# UNITED STATES PATENT AND TRADEMARK OFFICE

APPLICATION NO.	FILING DATE	FIRST NAMED INVENTOR	ATTORNEY DOCKET NO.	CONFIRMATION NO.
09/548,876	04/13/2000	Jason D. Miller	0-03A	7633

# Office Action Summary

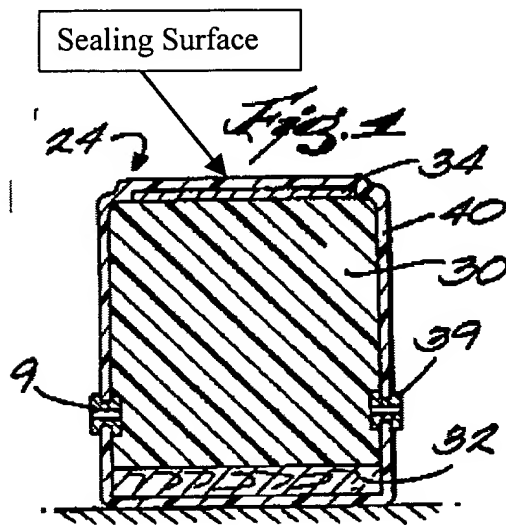
In regards to claim 1, **Styba** discloses a dock pad (24) adapted to seal against a vehicle parked against the dock pad, comprising a foam core (30); a cover (40) disposed on the foam core; and a heat shield (34) adjacent the cover, wherein the dock pad is adapted to seal against the vehicle by virtue of the foam core being compressible, the cover being pliable, and the heat shield being pliable. Although the heat shield (34) of **Styba** is noted for use as a puncture resistor, **Styba** also discloses that this material (34) could be "polyester". Polyester is well known in the art for its flexible and flame resistance characteristics. So, even though **Styba** does not explicitly state that the material (34) is a "heat shield", heat resistance is an inherent characteristic of the disclosed material - polyester.

In regards to claim 2, **Styba** discloses the heat shield (34) being interposed between the cover (40) and the foam core (30), see Figure 4.

In regards to claim 13, in Figure 4 below, **Styba** discloses a sealing surface and a mounting surface (MS) that face away from each other with at least a portion of the heat shield (34) extending substantially parallel to the sealing surface and being closer

to the sealing surface than the mounting surface (MS), wherein the sealing surface is adapted to seal against the vehicle and the mounting surface (MS) is adapted to be attached to a wall (16). (See Below).
